College of Engineering
Department of Nuclear & Radiological Engineering
University of Florida Training Reactor

Subject: University of Florida Training Reactor (UFTR) License Renewal (TAC NO. ME 1586),
DOCKET NO. 50-83

**Responses to NRC's RAIs
Regarding License Renewal for the UFTR**

Figure 2 schematic of UFTR secondary coolant system used for determination of heat exchanger inlet/outlet pressures.

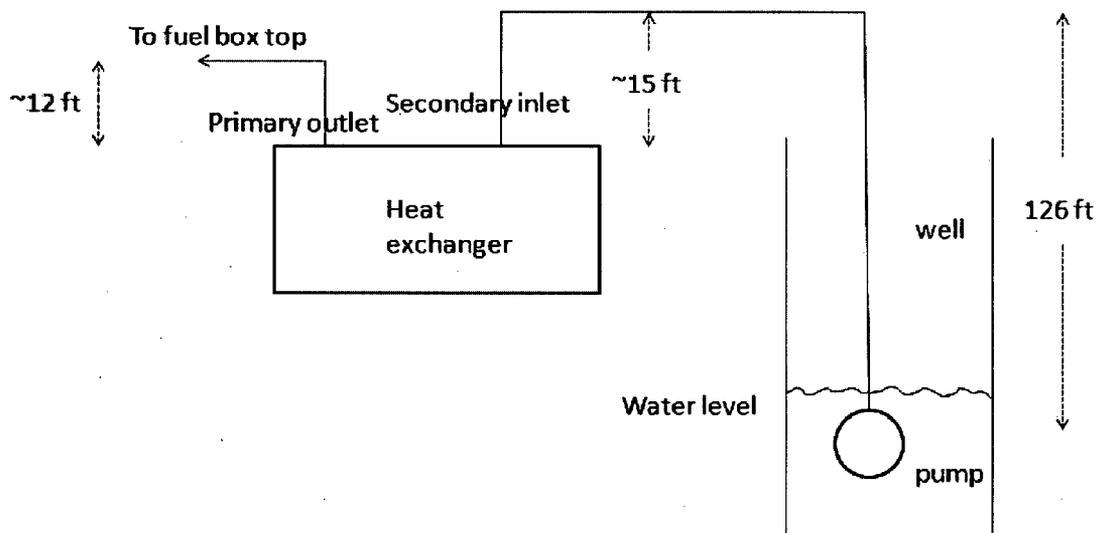
Question 1: *Your letter dated April 7, 2008, states that the normal operating pressure for the secondary side is not monitored, but that secondary flow rate is about 4 times higher than the primary flow rate so the dynamic pressure of the secondary system is expected to be higher than the primary system pressure. Therefore, if a significant leak is developed on the primary/secondary boundary, the resistivity of the primary water is expected to change, which is constantly monitored and controlled. The technical specifications (TSs) limits on primary flow rate are greater than 36 gpm or 41 gpm depending on fuel coolant channel spacing tolerance, and the TSs limits on secondary flow rate are greater than 60 gpm when using a well system and 8 gpm when using city water.*

Is the assumption that a significant leak would be detected in the primary water resistivity valid if the reactor is operating at the TS limit of 36 gpm or 41 gpm primary flow rate (or normal primary flow rate if it is in excess of the allowed TS limit) and 60 gpm or 8 gpm secondary flow rate? In your response, address how the primary and secondary pressures are affected by the flow characteristics in the heat exchanger.

The heat exchanger shell-side and tube-side inlet/outlet pressures are not monitored in UFTR. However, we can estimate the pressures based on the piping layout and pump characteristics. Figure 5-5 in UFTR SAR shows the schematic of UFR secondary coolant system. The figure is also attached in this document (Appendix A). A simplified version of Figure 5-5 in SAR is used here to estimate the primary outlet and secondary inlet pressures as shown in Figure 2

In conclusion, the secondary pressure remains higher than the primary pressure in the heat exchanger when operating on the well water. For city water, the primary pressure drop is still larger than the secondary pressure drop. The primary heat exchanger inlet pressure is likely higher than the secondary inlet pressure. So it is not valid to assume that the secondary pressure is always higher than the primary pressure. However, the activity release is limited even if there is leakage in the heat exchanger (See analysis in Question 2).

Figure 1 - Comparison of the activity release for different operation time as a function of sodium concentration (100 kW, 1 liter/hr, 200 gpm)

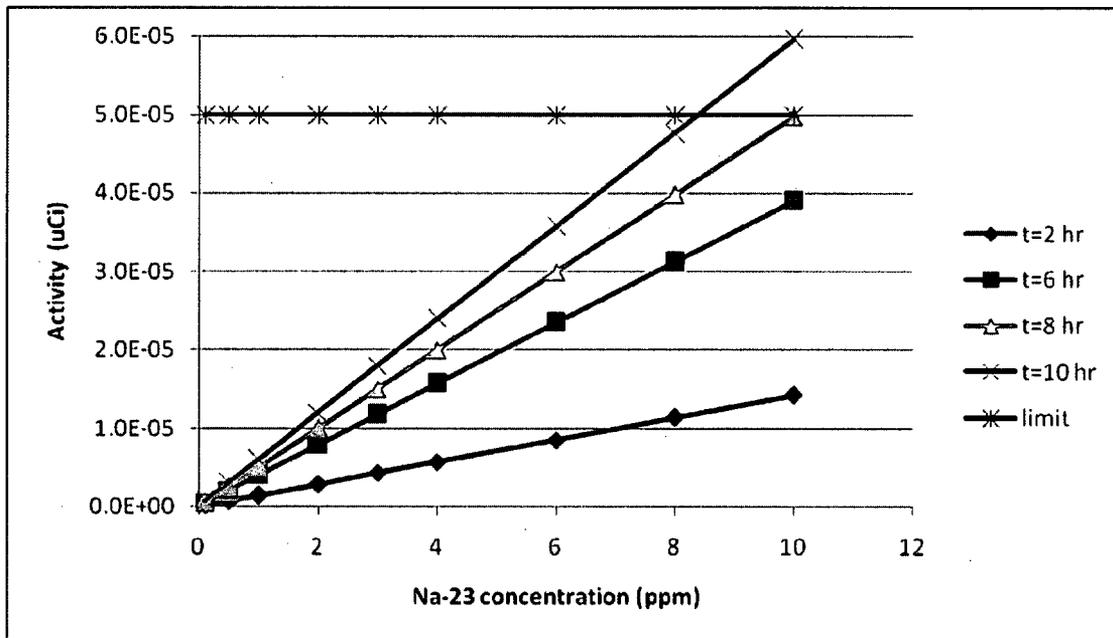
Question 2a: What is the basis for the ‘assumptions of 1 ppm sodium in the primary coolant, activation for 10 hours, and 1 liter/hour leak rate for 1 hour?’

Here, in order to examine the effect of higher Na concentration and longer operation times, we evaluate the activity release for concentrations in a range of 1-10 ppm for operation hours of 2 to 10 hrs. Figure 1 compares the activity release for different hours of operation as a function of Na concentration in the primary coolant. Note that these calculations are based on 1 liter/hr leakage rate, and 200 gpm secondary flow rate.

Above figure indicates that the activity is less than the release limit (5×10^{-5} uCi/ml) if sodium concentration is less 10 ppm for a case of 8 hrs of operation. Only the case with a Na-23 concentration of 10 ppm and an operation time of 10 hours exceeds the limit.

Figure 3 - Comparison of the activity release for different secondary flow rate as a function of Na-23 concentration for 1 liter/hr leakage (operation time of 6 hrs, 100 kW).

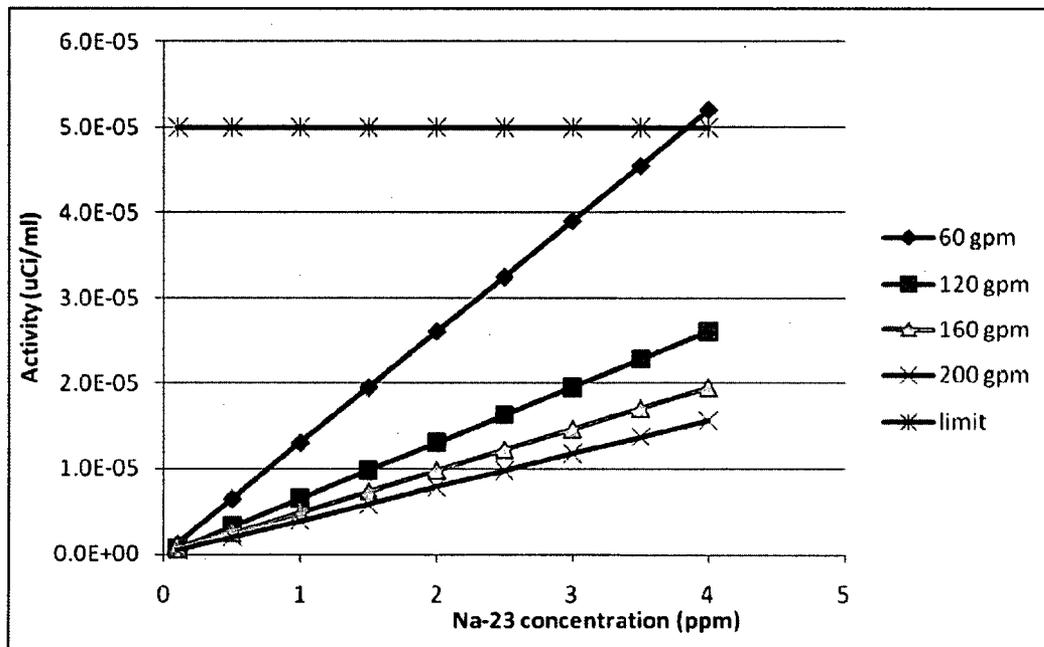
Question 2c. As discussed previously, the TS limit on secondary flow rate is 60 gpm when using well water and 8 gpm using city water. Therefore, provide an estimated effluent concentration assuming the allowed TS limits for secondary flow.

Well water is the only supply for UFTR secondary system now. Based on the current UFTR Technical Specifications, the nominal well water flow rate is ~200 gpm. A warning is triggered if flow drops to 140 gpm or less, and the reactor is tripped if the flow rate drops to 60 gpm or less. Figure 3 compares the activity release for different flow rates as a function of Na-23 concentrations, for an operation time of 6 hrs and leakage rate (primary to secondary) of 1 liter/hr at 100 kW.

Figure 3 shows that the only case exceeding the release limit is the case with 4 ppm Na-23 concentration and a secondary flow rate of 60 gpm.
